UNITED STATES PATENT AND TRADEMARK OFFICE

APPLICATION NO.	FILING DATE	FIRST NAMED INVENTOR	ATTORNEY DOCKET NO.	CONFIRMATION NO.
09/783,034	02/15/2001	Reza-Ur Rahman Khan	1875.0210000	5713

Office Action Summary

DETAILED ACTION

FIG. 3

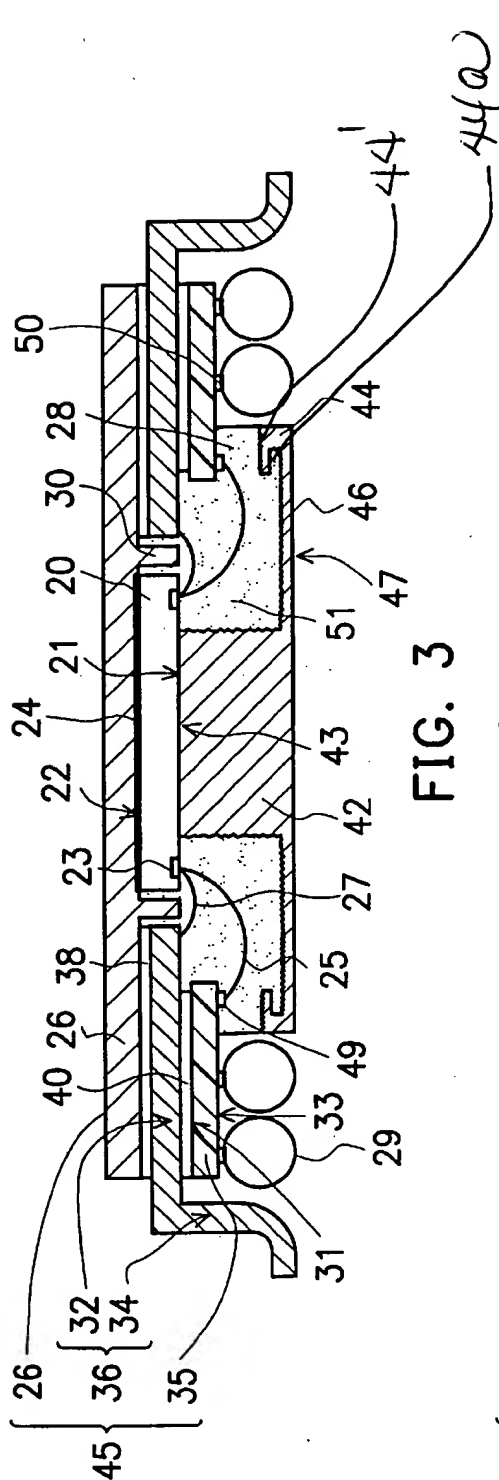
5. Claims 1-3, 9, 10, 12-14, 16-19, 25-27, 29-31 and 33-36 are rejected under 35 U.S.C. 102(e) as being anticipated by Lin (US 6,184,580).
6. Regarding claim 1, Lin (e.g. fig. 3) shows a ball grid array package comprising:

- A substrate 35 that has a first surface 31, a second surface 33, and a central window shaped aperture that extends through the surfaces;
- A stiffener /heat spreader 26 attached to the first substrate surface;
- A portion of the stiffener/heat spreader that is accessible through the central window-shaped aperture;
- An IC die 20 that has a first surface 24 and a second surface 21, wherein the first IC die surface is mounted to the accessible portion of the stiffener/heat spreader;
- And a drop-in heat spreader 42 that has a surface 43 that is mounted to the second IC die surface.

33. Regarding claim 7, Lin shows that the planar drop-in heat spreader 42 has a ridge 44a, a first surface 43 parallel to a second planar surface 44' (see attachment fig.

3). As shown in figure 3, the first planar surface is greater than the second planar surface. Lin does not explicitly disclose a circumferential surface. Nonetheless, this limitation, absent any criticality, is only considered to be an obvious modification of the shape of the projection surface disclosed by Prior Art as the courts have held that a change in shape or configuration, without any criticality, is within the level of skill in the art as the particular shape claimed by applicant is nothing more than one of numerous shapes that a person having ordinary skill in the art will find obvious to provide using routine experimentation based on its suitability for the intended use of the invention. See In re Dailey, 149 USPQ 47 (CCPA 1976).

40. Regarding claim 15, Lin shows most aspect of the instant invention including a surface 44 between the first and second drop-in heat spreader surfaces. Also, this surface is partially exposed (the side wall of the projection 44). Lin does not explicitly disclose that the surface 44 is a circumferential surface. Nonetheless, this limitation, absent any criticality, is only considered to be an obvious modification of the shape of the projection surface disclosed by Prior Art as the courts have held that a change in shape or configuration, without any criticality, is within the level of skill in the art as the particular shape claimed by applicant is nothing more than one of numerous shapes that a person having ordinary skill in the art will find obvious to provide using

FIG. 4

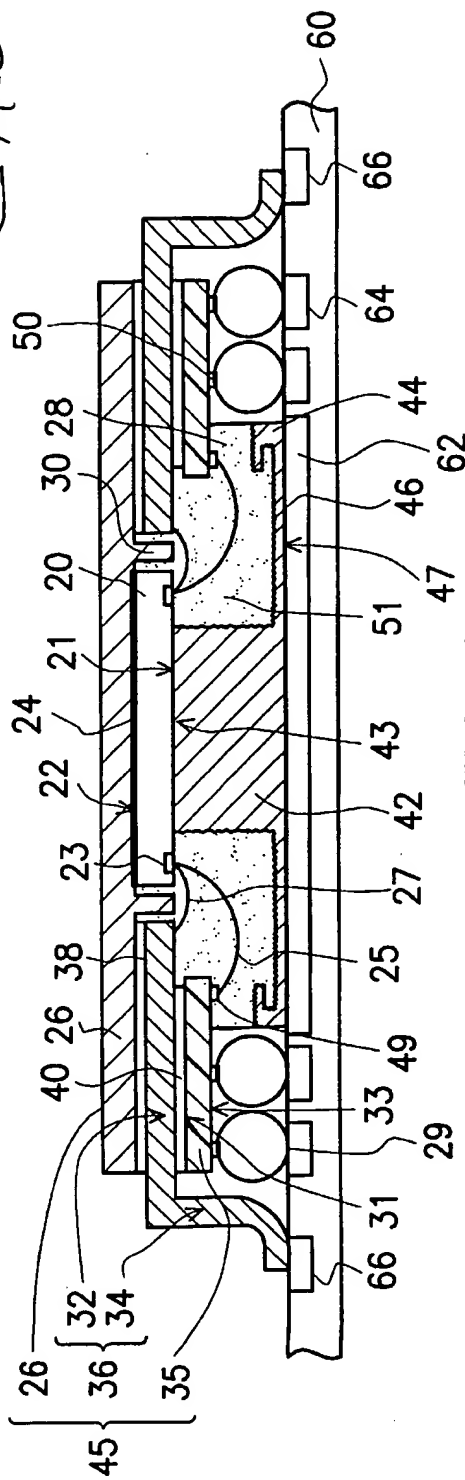
31. Regarding claim 5, Lin shows that the second drop-in heat spreader surface 47 is attached to a printed circuit board 60 (e.g. fig. 4).
